STAFF REPORT

To:	**Snyderville Basin Planning Commission**
From:	**Tiffanie Northrup-Robinson, County Planner**
Date of Report:	**February 1, 2012**
Date of Meeting:	**Wednesday, February 8, 2012**
Type of Item:	**Village at Kimball Junction Specially Planned Area Rezone and Development Agreement – Work Session**

- Project Name: Village at Kimball Junction SPA and DA
- Owner(s):Lot 4A - Fred Barth, Penrad Properties **(Del Taco)**
  Lot 1-A,B,C,D,E,F - O'Brien Kiernan Investment Co **(OBK)**
  Lot 2 and 2B - Smith's Food and Drug Centers, Inc. (**Smith's)**
  Lot 2A - Well's Fargo Bank representing the John Jarman Est. **(Jarmen)**
- Applicant(s): Paul Hitzelberger, **Del Taco**
  Ross Varner, **OBK**

Exhibit 2

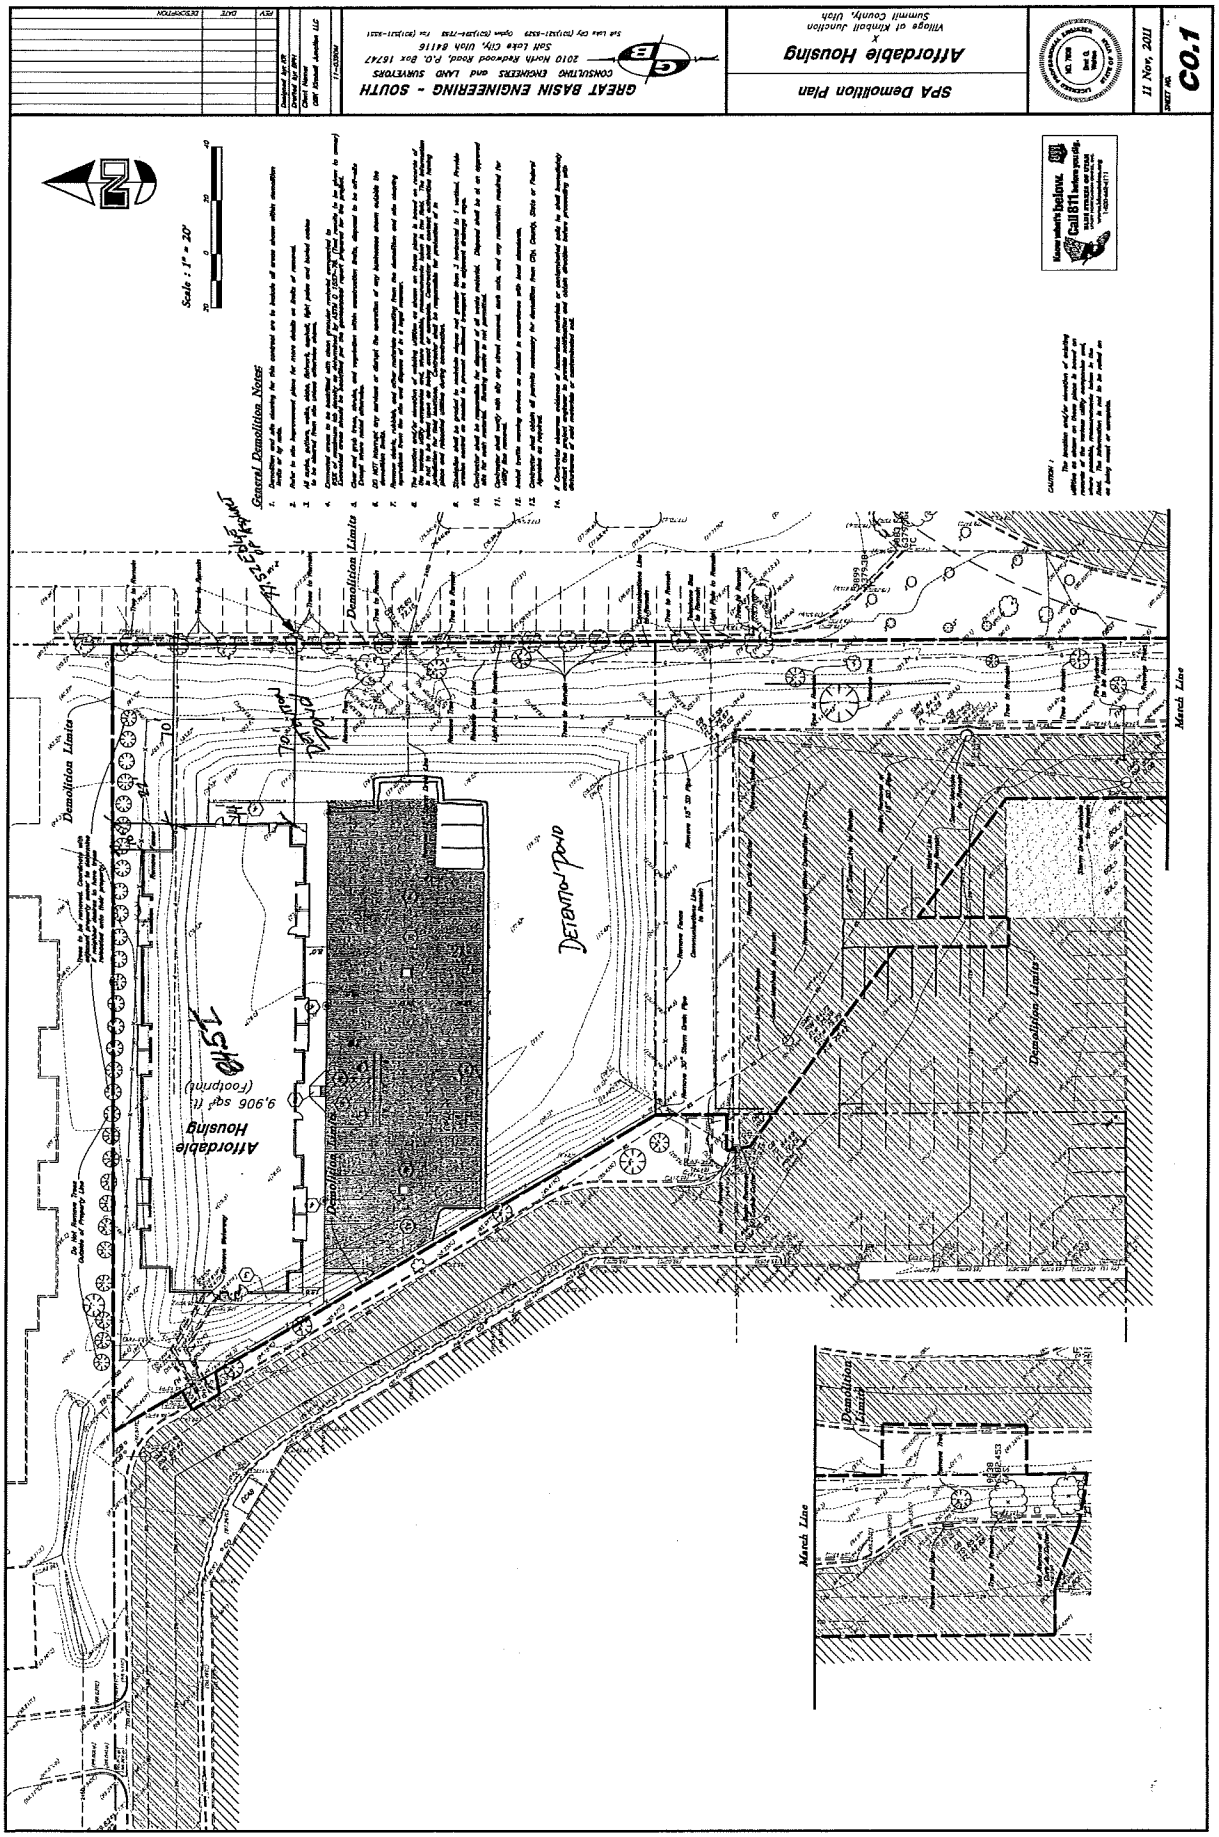
2. Reconfigure the location of the AH building on Parcel D of VKJ and modify the roof to lower the overall height of the structure.
    a. The current site plan of the building obstructs all of Newpark One's view of the Utah Olympic Park ("UOP"), as well as, most of the west mountain range. In

1. Place the backside of the building, as close as possible and parallel to Holiday Inn's south property line and pushed as close to the detention basin's west property line as possible. Cottonwood commissioned a sight study by GSBS and believes that this orientation provides the least amount of view impairment for our building. (See Exhibit B for the site plan provided by Bret Wahlen)
2. To additionally lower its overall height, we recommend that a flat roof be used on the building.
3. Newpark One has the opportunity to provide input regarding the exterior elevation of the AH building. We obviously want something that fits in the area and is pleasant to look at.
4. The drainage system from the AH property to Newpark One be upgraded to take the water flow underground and reduce the chance of flooding.

SHEET NO.
C1.1

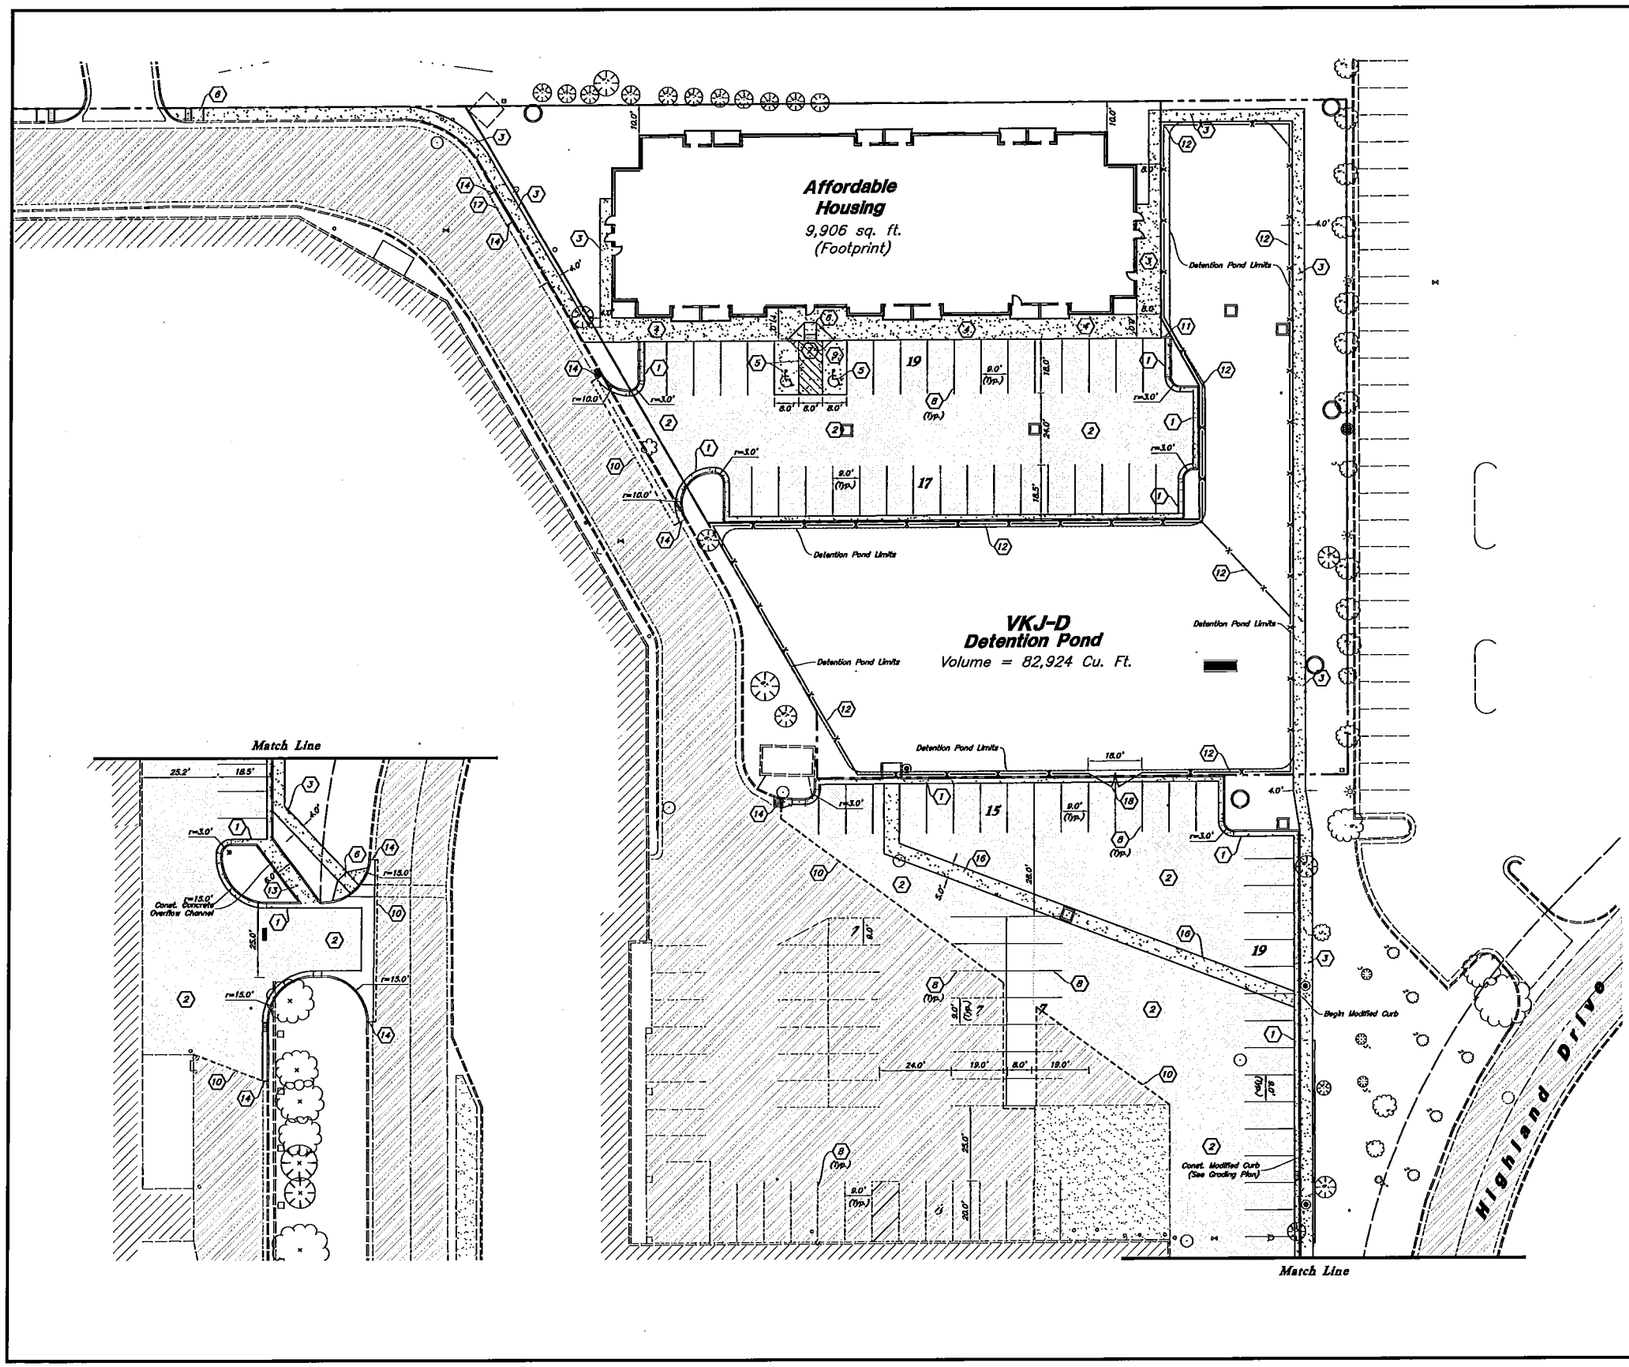
a. Smith Expansion
    i. Should there be a sheet C3.2 – possibly okay?
    ii. ADA ramp needed east end of the mid parking lot crossing.
    iii. C1.1 scales at 38' for nose to nose parking - typically 40' is required.
    iv. NW corner of the financial pad – non-directional ADA ramp

b. Financial Institution
    i. NW corner – orient the ADA ramps to receiving ramp so visually impaired are directed.
    ii. C2.1 – is the grading correct – teller / floor height (97.00) 3' above the car height (+/-94.0)
    iii. C5.1 – silt fence is on the uphill side of the parking lot.

f. Fuel Center
   i. Non-directional ADA ramp.
   ii. No building set back provided.
   iii. Text conflicts on the grading plan near the fuel tank.
   iv. What are the other state provisions for the Underground Storage Tank?
   v. Provide enhanced SWP3 plan details associated with fuel delivery. See specifics associated with Ordinance 381A.

g. Affordable Housing
   i. The primary concern is housing interaction with truck traffic and the truck dock. This affects the access and the general area circulation and safety. Please justify the design.
   ii. Related to the above, the access to Highland Drive is new. Safety and function relative to the truck dock area is a concern.
   iii. Storm drain overflows to Newpark's landscape and Highland Drive – acknowledgement by Newpark is recommended. It is likely an improvement of existing, which is directly into the Cottonwood 1 building. However, the pond size is modified.
   iv. A geotechnical report is critical for the site. Construction is proposed on 8' of fill.
